### **Development and Planning Services Committee**

**Monday, March 4, 2019**

RE: Development Variance Permit Application No. VP-491  
Subdivision and Development Servicing & Mobile Home Park Bylaws

SUBJECT: Variance Permit Application No. VP-493 (Servicing)  
Legal: Lot 10, Section 35, Township 20, Range 10, W6M, KDYD, Plan 31502  
Civic Address: 1230 – 52 Avenue NE  
Owner/Applicant: Brown, C. & D. / Browne Johnson Land Surveyors

**No Road Upgrades to City's RD-14 Standard (Proposed)**

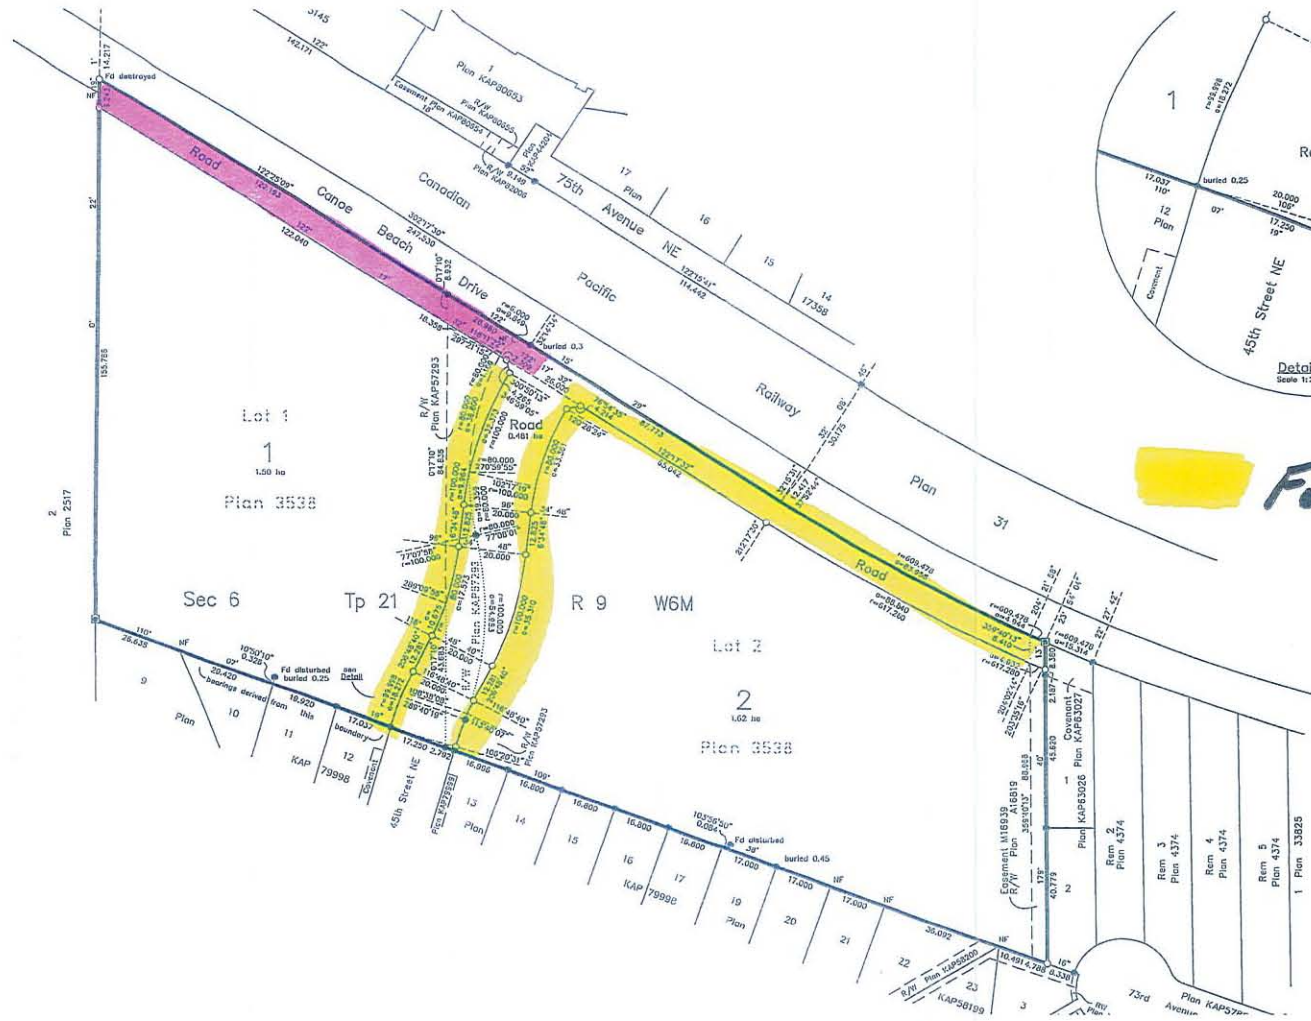
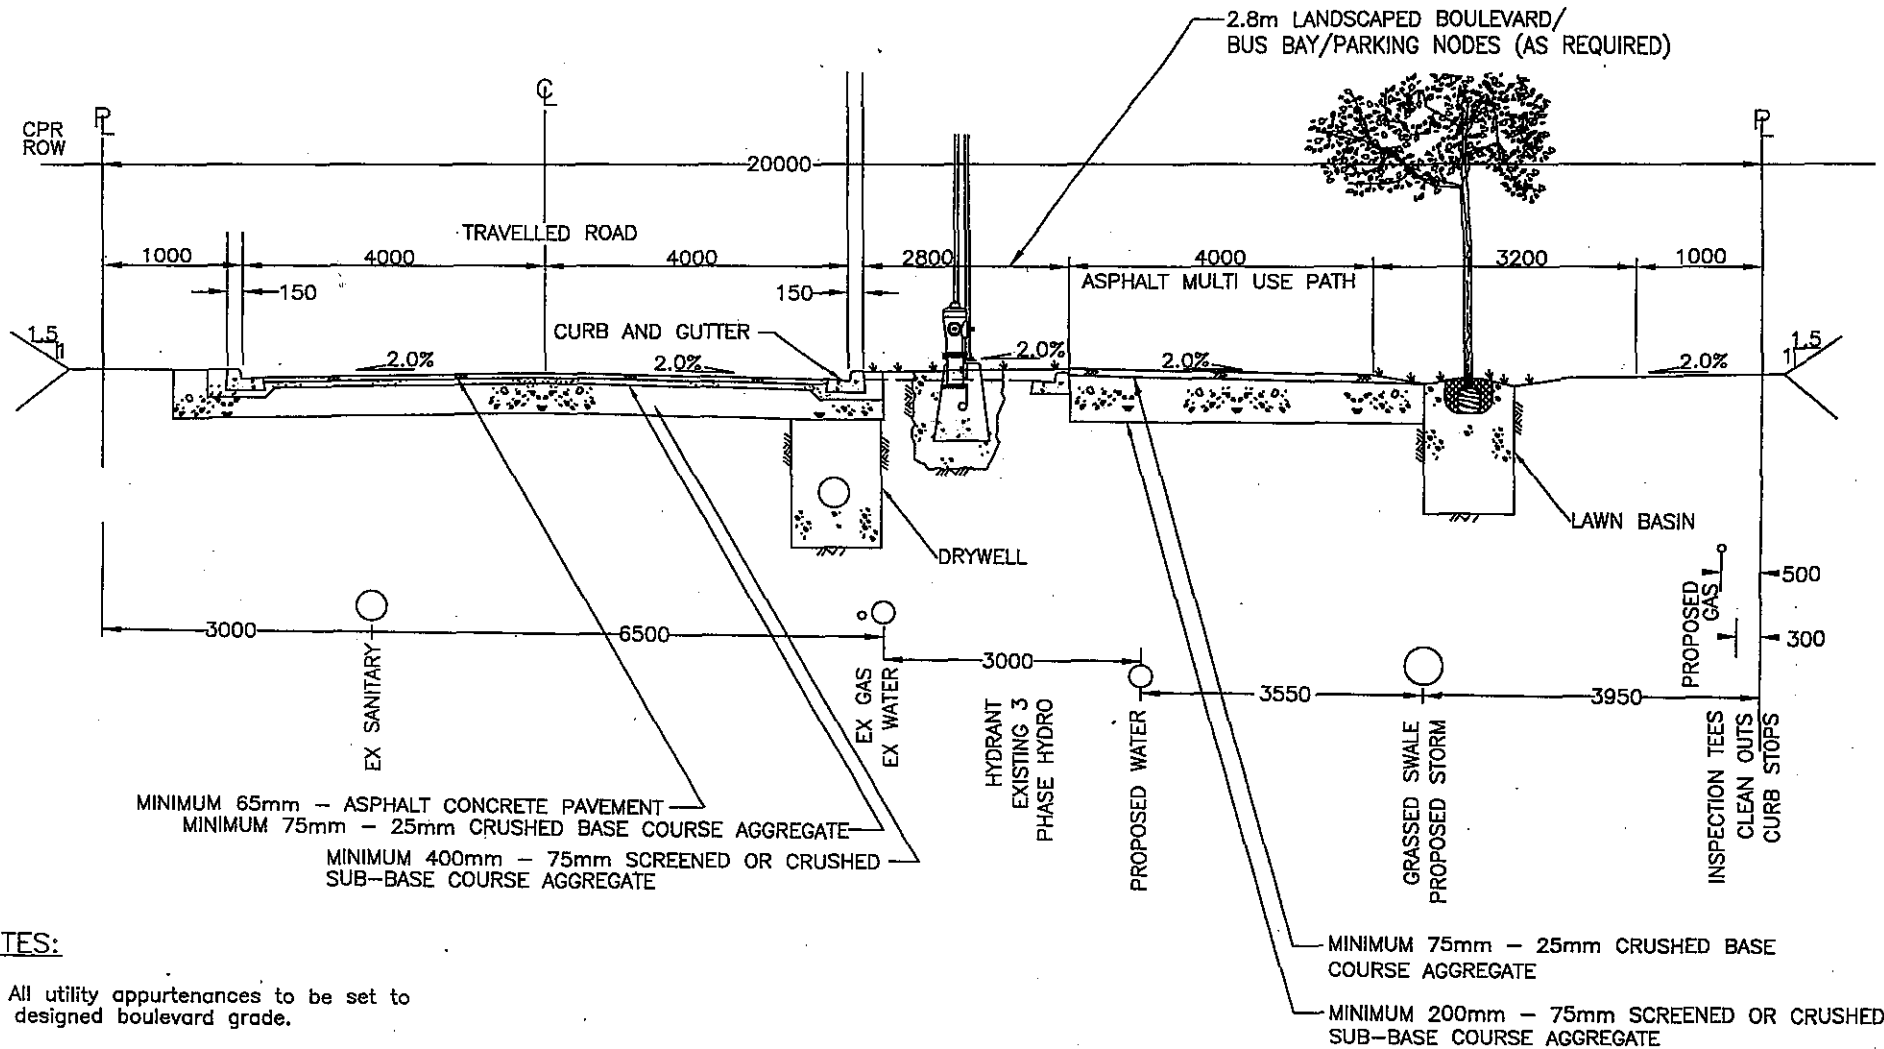
If approved, the DVP would waive the requirement for the applicant to upgrade the Canoe Beach Drive (CBD) - approximately 125 m of frontage along the north boundary of Lot 1 after dedication - to the RD-14 Standard. The RD-14 Road Cross Section from the SDS Bylaw is attached in AAPENDIX 3.

**No Perimeter Fencing  
(Proposed)**

**Full Road Upgrades Proposed**

# Sketch Plan of Proposed Subdivision of Lot 10, Sec 35, Tp 20, R 10, W6M, KDYD, Plan 31502

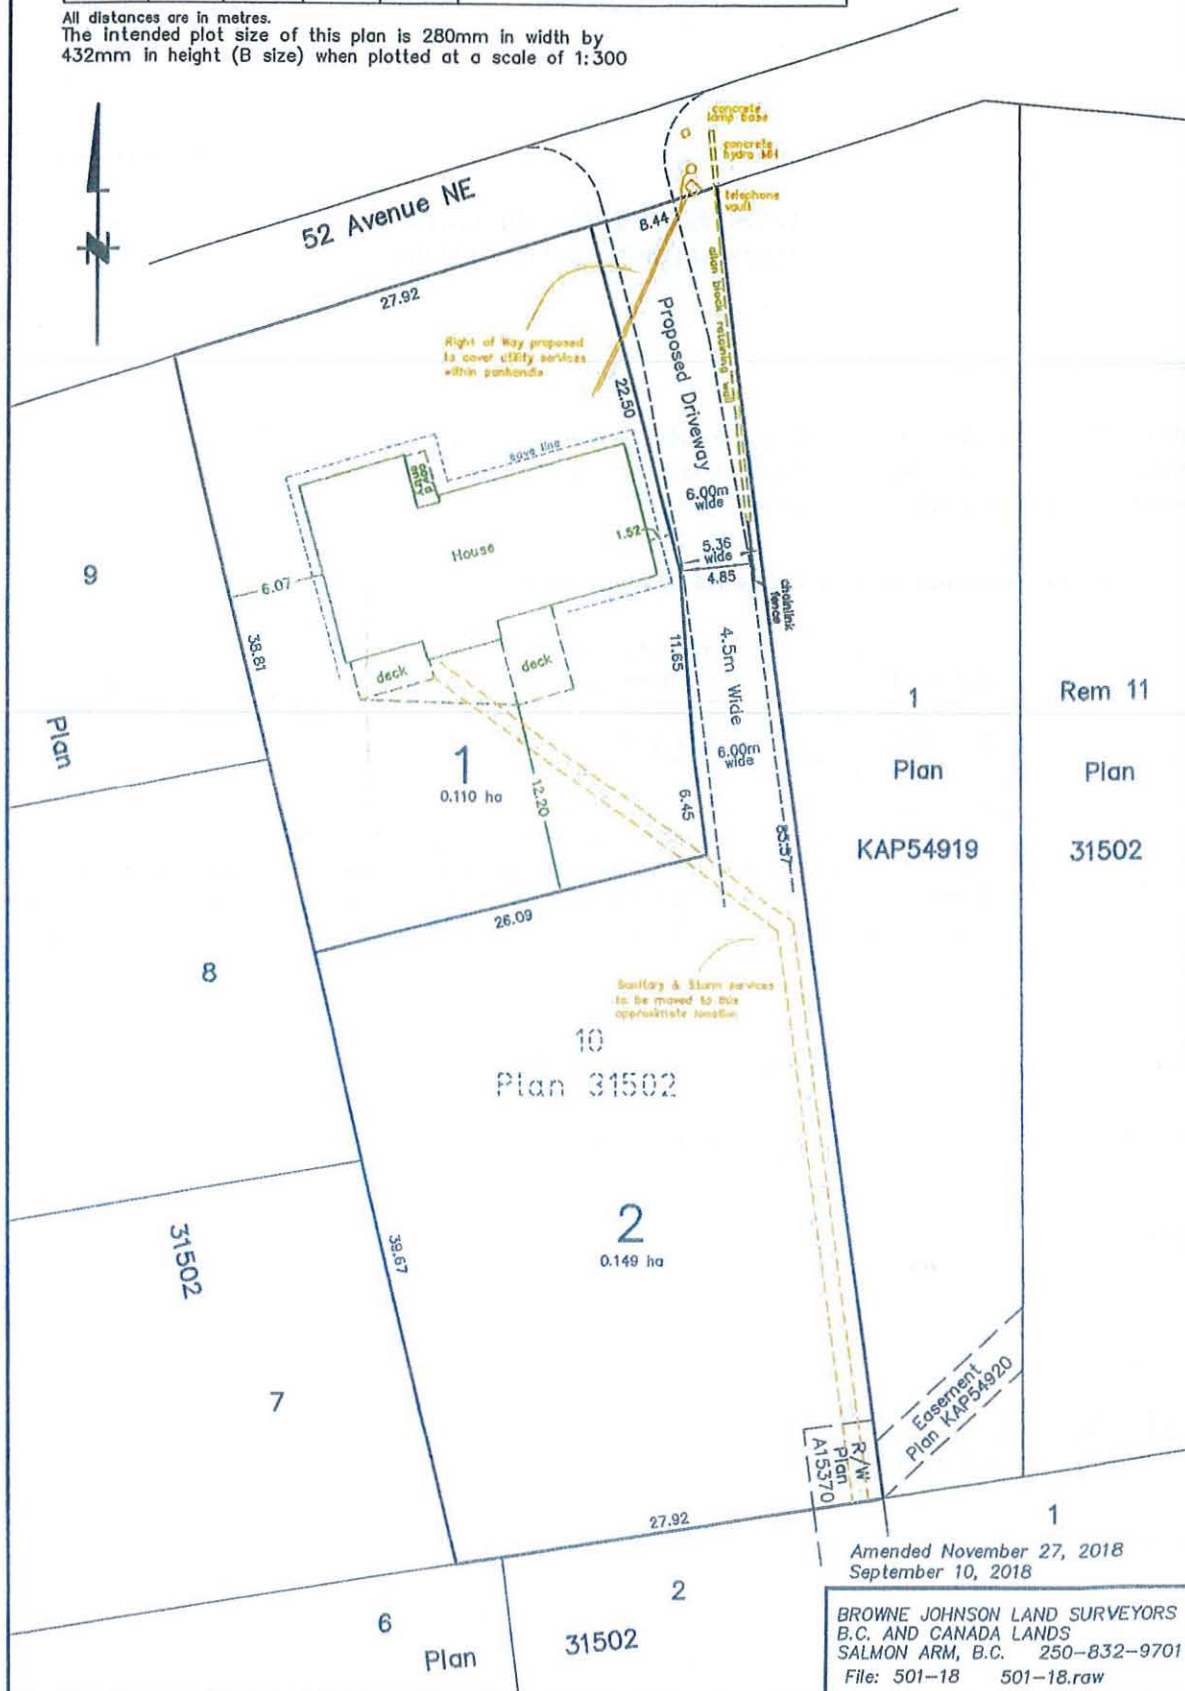
1. Waive the requirement to upgrade (construct sidewalk) the south half of 52 Avenue NE for the entire frontage of the subject property; and
2. Reduce the minimum width requirement for a panhandle from 6.0 m to 5.3 m, as shown in Schedule A.

The reduction in panhandle width requested would allow for the setback requirements from the existing house to be maintained at the southeast corner of the existing building, with the panhandle maintaining the standard 6 m width throughout the majority of its length, narrowing to 5.3 m only at the southeast corner of the existing house. The City's Policy 3.11 detailing emergency vehicle access specifications requires a clear width of no less than 4.5 m and a load carrying width of 3.5 m.

Staff and previous Council decisions have shown a reluctance to support panhandle widths less than 6 m for a number of reasons, primarily safety related. However, as previously noted, the reduction in panhandle width requested would allow for the setback requirements from the existing house to be maintained at the southeast corner of the existing building, with the panhandle maintaining the standard 6 m width throughout the majority of its length. A full 6 m panhandle could be alternatively achieved through a setback variance reducing the setback from the existing house by 0.64 m. Furthermore, the requested reduction is relatively minor (6 m reduced to 5.36 m), for a relatively short length (approximately 15 metres), and the resulting driveway exceeds the driveway standards dictated by Policy 3.11 (clear width of no less than 4.5 m and a load carrying width of 3.5 m) attached as Appendix 9.

The Subdivision and Development Servicing Bylaw No. 4163 requires the width of a panhandle to be at least 6.0 meters where the Parcel has no further Subdivision Potential. The existing configuration of the lot does not practically allow for further subdivision.

Policy 3.11 dictates the requirements for emergency vehicles accessing buildings. For Single Family Dwellings Policy 3.11 requires a roadway with a clear width of no less than 4.5m and a load carrying width of 3.5m. The proposed driveway has a clear width of a minimum 5.36m and a carrying width of 4.5m. Therefore, the proposed driveway meets the width requirements of Policy 3.11.

The Engineering Department recommends that the requested variance be granted, subject to the driveway conforming to Policy 3.11.
